Re: Federal "C" Well No. 1 - SWD Permit

# FEDERAL "C" WELL NO. 1 PROPOSED INTEGRITY TESTING SCHEDULE

## PROPOSED SWD CONVERSION

# PROPOSED SWD CONVERSION

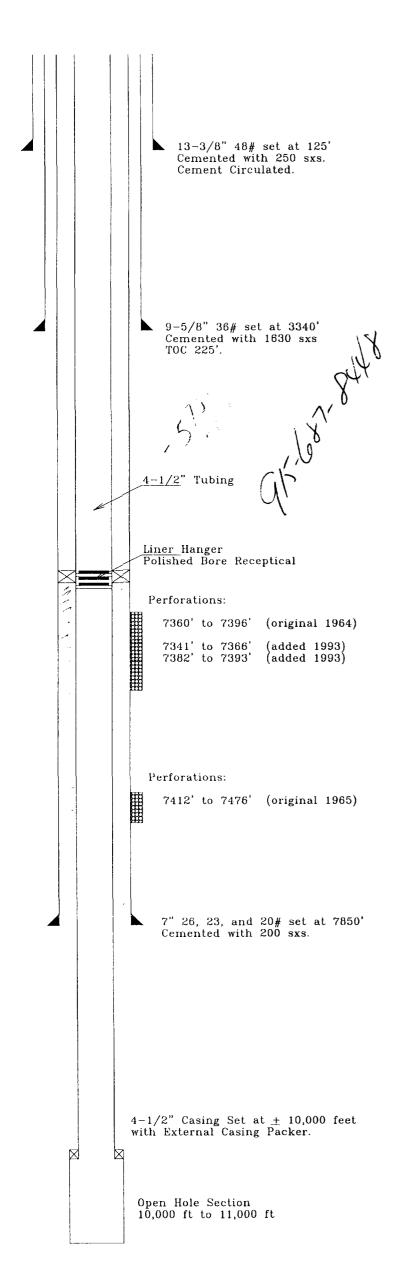
In addition to the proposed testing schedule, a revised wellbore schematic is attached. The revised schematic shows the 4-1/2" liner set at  $\pm$  7600 feet as opposed to the original setting depth of 7250 feet. The schematic also illustrates recent work that was completed on the well to isolate and cement squeeze a casing leak at 5882 to 5898 feet.

LINER 4-1/2" 11.6# set from 7600' to 10,000'. Cement with 300 sxs. Polished-Bore Receptical at 7600'. External Casing Packer and Cement Stage Tool at 10,000'.

TUBING 4-1/2" tubing to 7600'. Lined with "Duoline-20" Fiberglass-Epoxy Lining

CASING LEAK Isolated Casing Leak between 5898' and 5882'. Perforated 6340' to 6341'. Cemented squeezed perforations 6340' to 6341' with 100 sxs cement. Pumped 985 sxs cement through casing leak at 5898' to 5882'. Circulated cement to surface between 9-5/8" and 7" casing annulus.
